CITY OF CODY  
PLANNING, ZONING, AND ADJUSTMENT BOARD  
TUESDAY SEPTEMBER 24, 2019  
CITY HALL COUNCIL CHAMBERS @ 12:00 NOON

**CITY OF CODY  
PLANNING, ZONING AND ADJUSTMENT BOARD  
STAFF REPORT**

**CITY OF CODY  
PLANNING, ZONING AND ADJUSTMENT BOARD  
STAFF REPORT**

<b>MEETING DATE:</b>	SEPTEMBER 24, 2019	<b>TYPE OF ACTION NEEDED</b>	
<b>AGENDA ITEM:</b>		P&Z BOARD APPROVAL:	
<b>SUBJECT:</b>	CONCEPT PLAN REVIEW OF THE CODY LEGACY ESTATES PLANNED UNIT DEVELOPMENT. PUD 2019-01	RECOMMENDATION TO COUNCIL:	
<b>PREPARED BY:</b>	TODD STOWELL, CITY PLANNER	DISCUSSION ONLY:	X

**SITE PLAN**

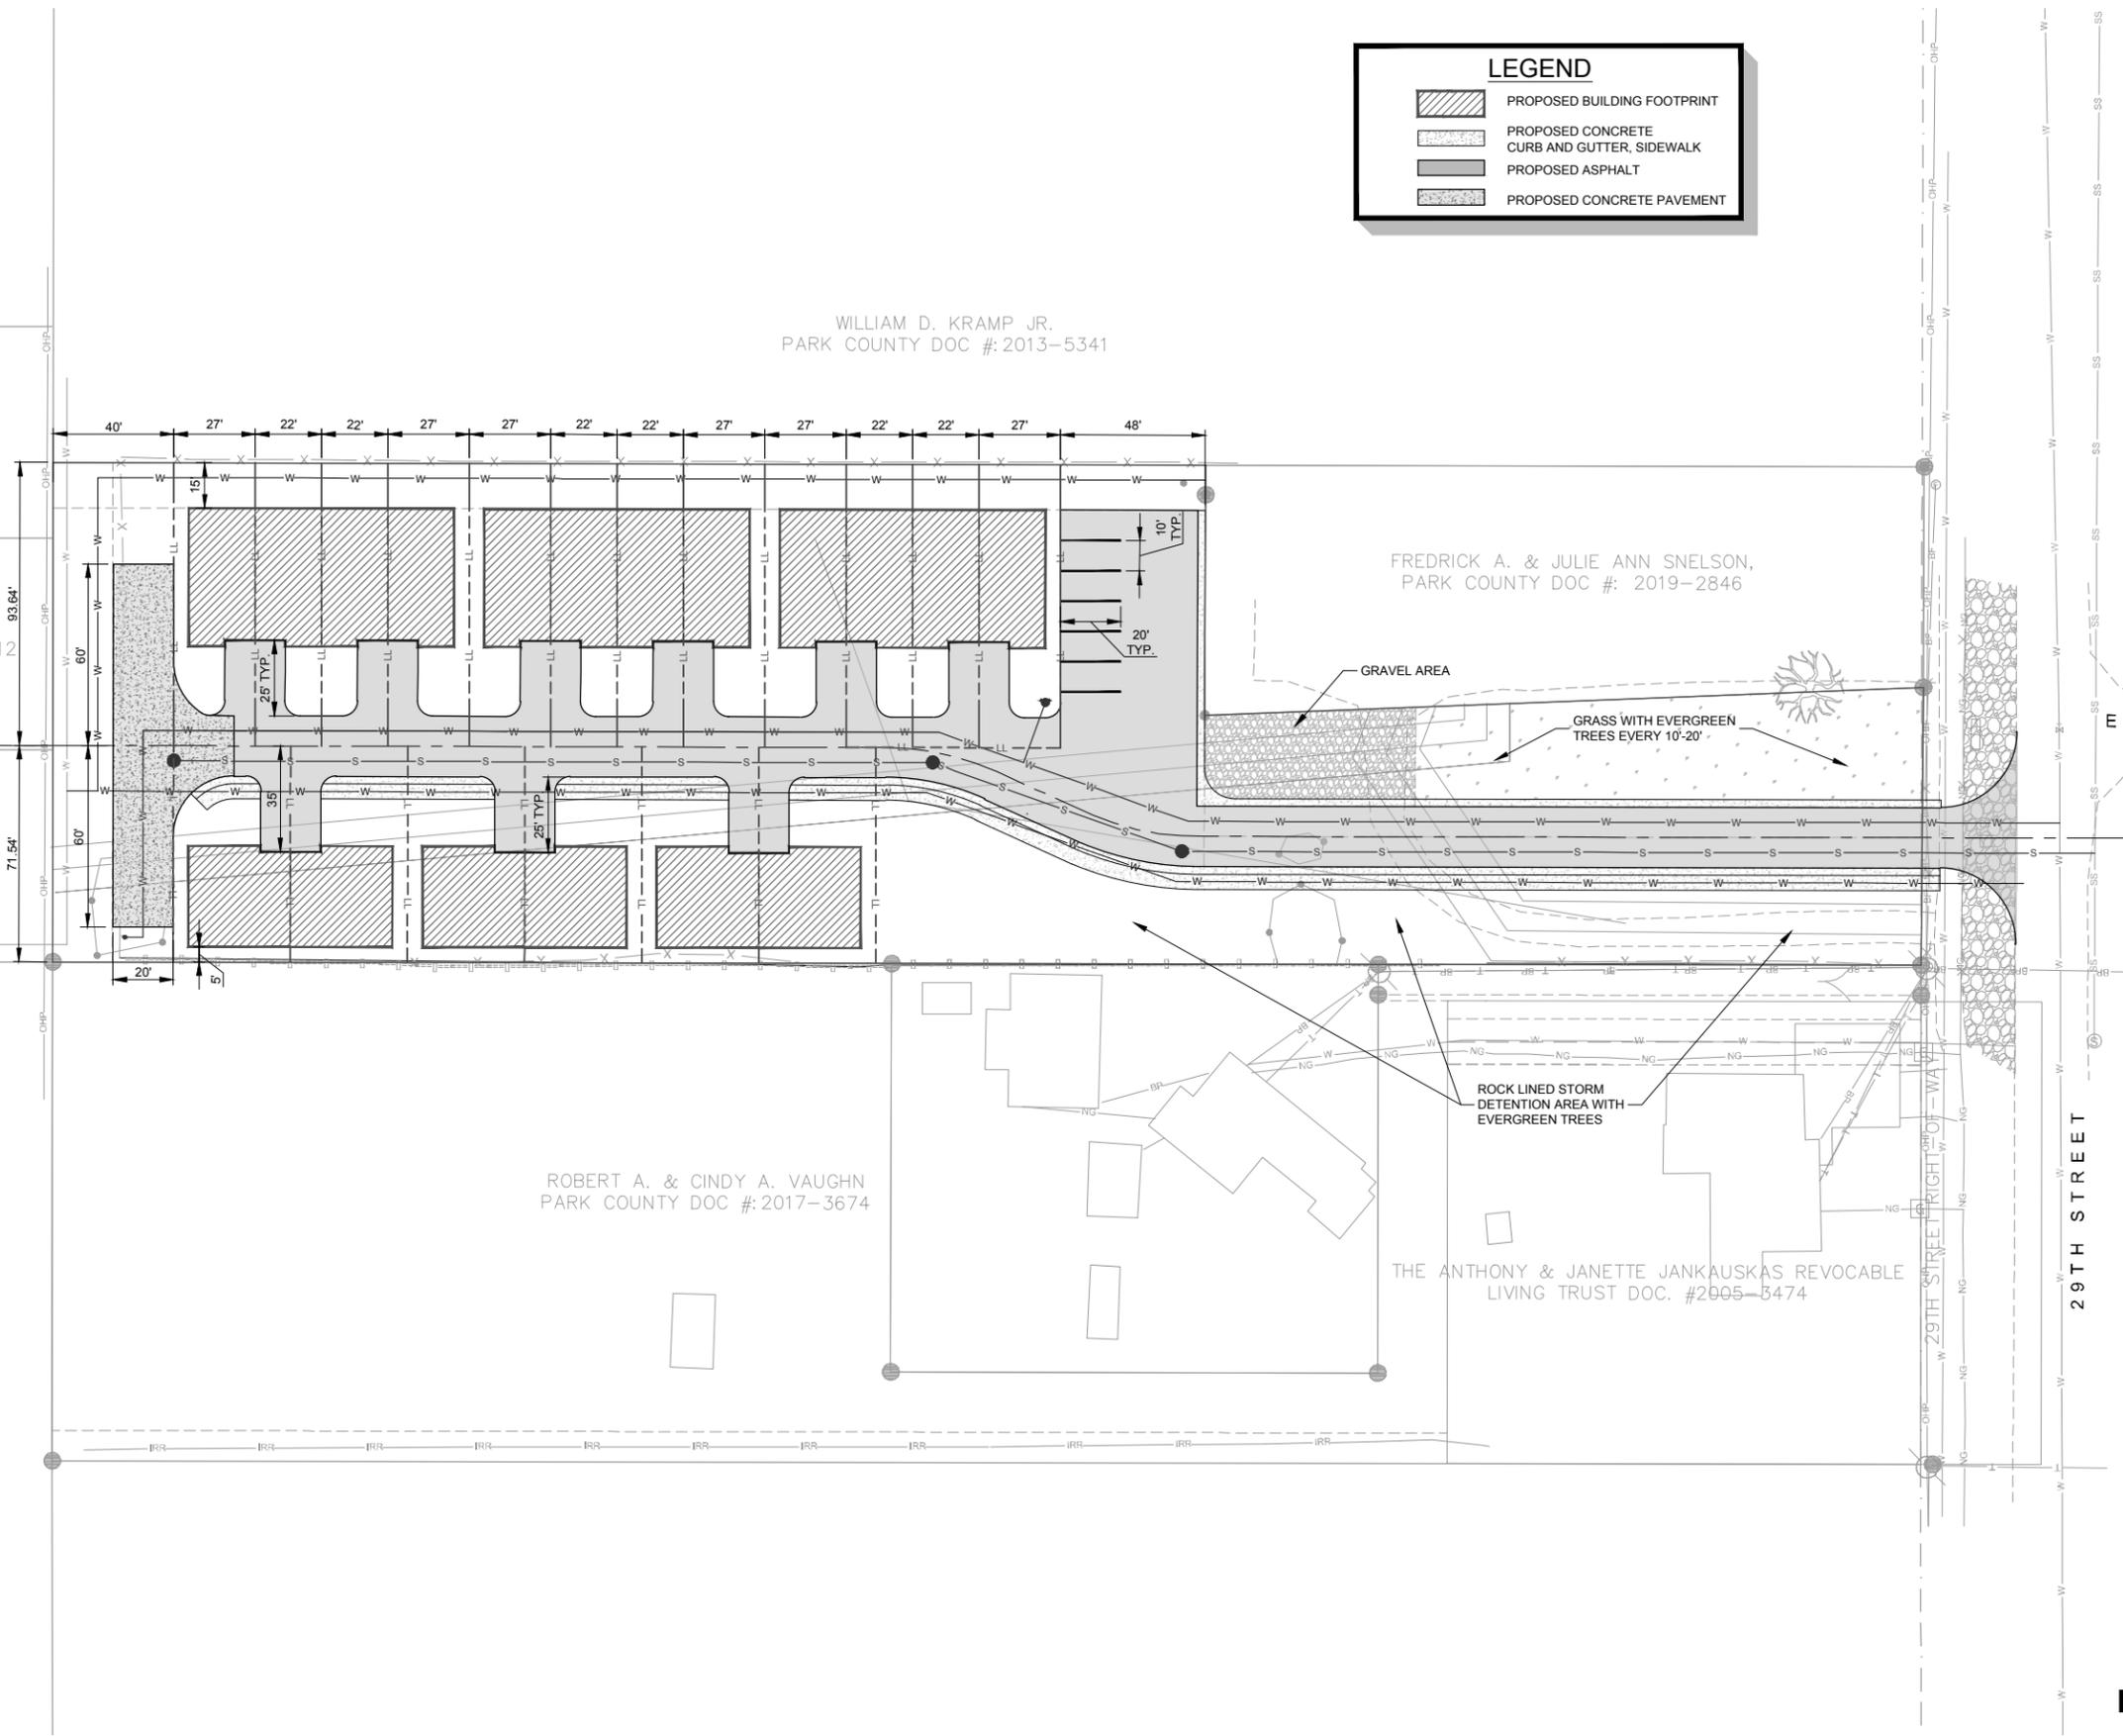
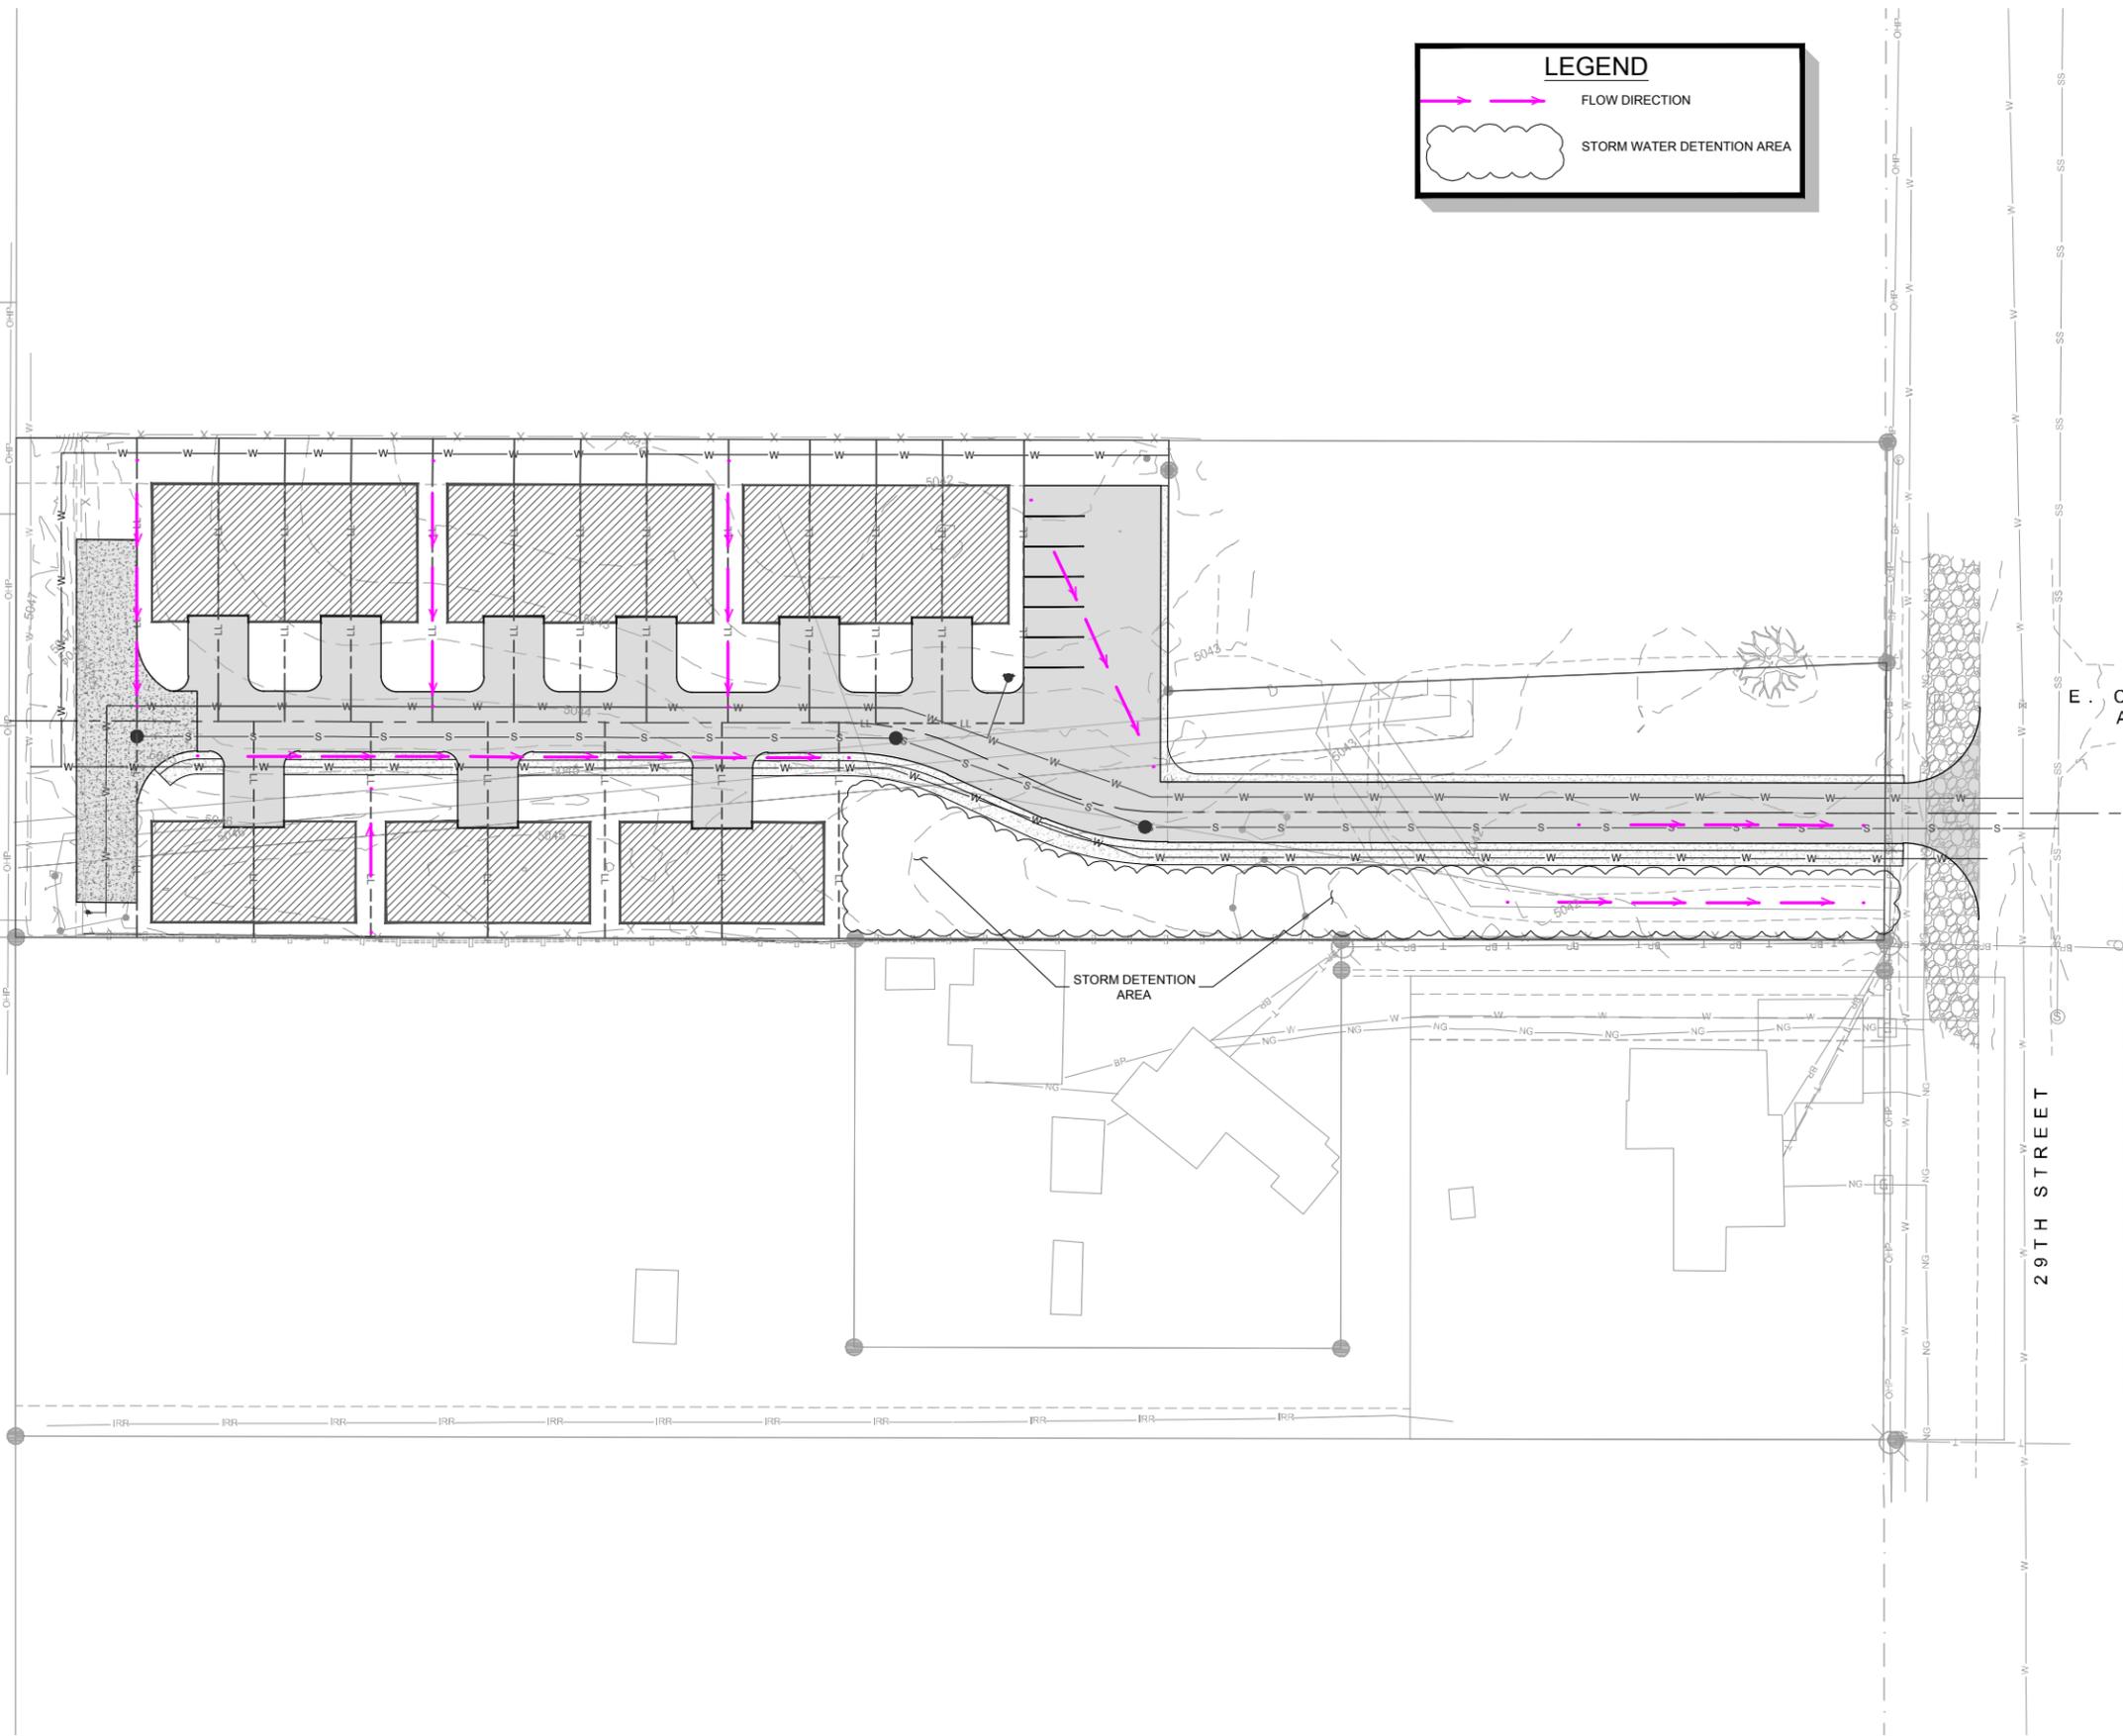
1. Are the uses in the common areas situated in the best manner to allow use by all of the residents? (Put drainage basin on both sides of the road near 29th Street and use the area east of the duplexes for a landscaped or play area?)
2. Is the developer committing to follow all standards of the R-3 zone that are not specifically outlined in the application? (home occupations, lot coverage, etc.)
3. Is a more detailed landscape plan needed?
4. Should the landscaping standards found in the supplemental standards for multi-family development (10-8-2(M)) be used as a guideline for landscaping on the individual lots?
5. Should a 5-foot rear setback be allowed on the back side of the duplexes? (across entire lot or only a portion?)

6. Talk through placement of utility boxes and services—units with side access not as much of an issue, but middle units would end up with everything on the front of the building if not planned otherwise.
7. Are the parking dimensions, placement of sidewalk, etc. adequate to avoid vehicles blocking the sidewalk? (Can buildings be shifted further north? Would require reduction of standard 15-foot rear setback on north units.)
8. Is a rock-lined detention facility really the intent of the common area requirement? —technically only roads, parking, and private yards are excluded. Options for grass? Buried infiltration trench?
9. What do they really mean by “dryscaped” common area? (No common area is proposed to be irrigated.)
